The Glitch:

The Fix:

➤ Figure 1

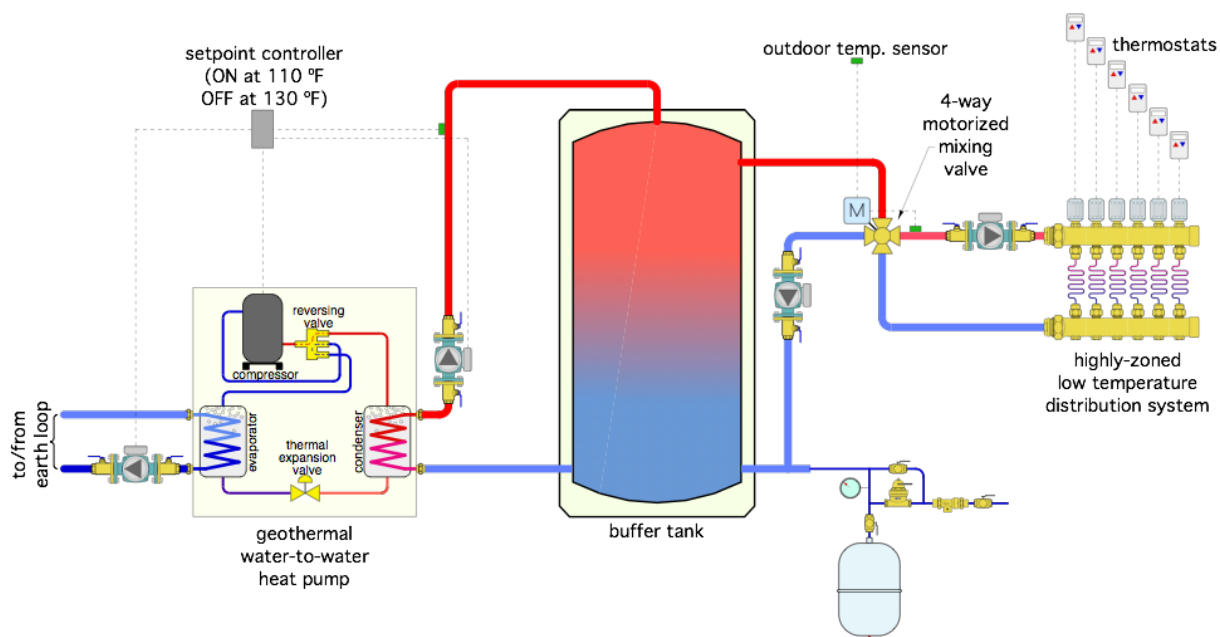
An installer is asked to connect a single speed geothermal water-to-water heat pump to a highly-zoned low temperature hydronic distribution system. The installer realizes that when a single speed heat pump is connected to such a distribution system, it is essential to use a buffer tank, so one is installed, as shown in Figure 1.

The system uses a temperature setpoint controller to operate the heat pump so the buffer tank is maintained between 110° F and 130° F. It also uses a 4-way motorized mixing valve to control the supply water temperature to the distribution system based on outdoor reset control. At design load, the distribution system requires 125°. The heat pump is enabled to operate whenever any of the zone thermostats call for heat. The system has a 2 gallon expansion tank.

Can you identify several details that are wrong, and propose a better design?

8. The original system shows a circulator, on the right side of the tank, pumping toward the point of no pressure change. This circulator is not necessary. Even if it were, it's not in the correct location relative to the point where the expansion tank connects.

9. The sensor for the mixing valve is shown very close to the outlet of that valve. Mixing may not be completed at this point and thus the temperature felt by the sensor may not be the true supply temperature to the heat emitters. Always locate the supply temperature sensor for a mixing valve downstream of the circulator (assuming that the circulator is on the supply side of the heat emitters).

The key to good performance with water-to-water heat pumps is keeping the load water temperature as low as possible. It makes no sense to maintain the buffer tank at a higher temperature than necessary, and then mix down to achieve the required supply water temperature to the heat emitters. The 4-way mixing valve, which is specifically intended to interface a conventional boiler to a low temperature load is completely unnecessary, and has been eliminated in Figure 2.

1. Set up the buffer tank in a 3-pipe configuration to allow direct-to-load heat transfer between the heat pump and distribution system when both are operating at the same time. Also avoid buffer tanks configurations where flow enters vertically at the top of the tank.

2. Install a check valve between the heat pump and buffer tank to prevent reverse thermosiphoning when the tank is warm and the heat pump is off. Without this valve, which might be integrated into the circulator, warm water will slowly flow backwards through the inactive heat pump and its piping, unnecessarily dissipating heat to the surrounding space.

3. Use an outdoor reset controller to turn the heat pump and its associated circulators on and off based on the temperature at a sensor located in a well at the mid-height of the tank. This keeps the water temperature just warm enough to maintain comfort in the building while also allowing the heat pump to operate at the highest possible COP.

4. Based on an estimated system volume of 120 gallons, an assumed system height of 10 feet, a maximum water temperature of 120°, the expansion tank needs to have a minimum volume of 4 gallons.

5. The original system lacked any means of differential pressure control on the highly zoned distribution system. This has been corrected by using a variable-speed pressure-regulated circulator for the distribution system.

6. The original system lacked a central air separation device. This has been added in Figure 2.
7. The original system lacked a means of removing air from the top of the buffer tank. A float-type air vent has been added at the top of the tank in Figure 2.

10. Notice that the expansion tank is connected to the buffer tank. Thus there will be very little change in the pressure within the buffer tank when these circulators operate. Both circulators in Figure 2 have been located so that they pump away from the buffer tank.

11. A drain valve has been added to allow the buffer tank to be emptied if ever necessary.
12. A pressure relief valve has been added near the expansion tank connection.
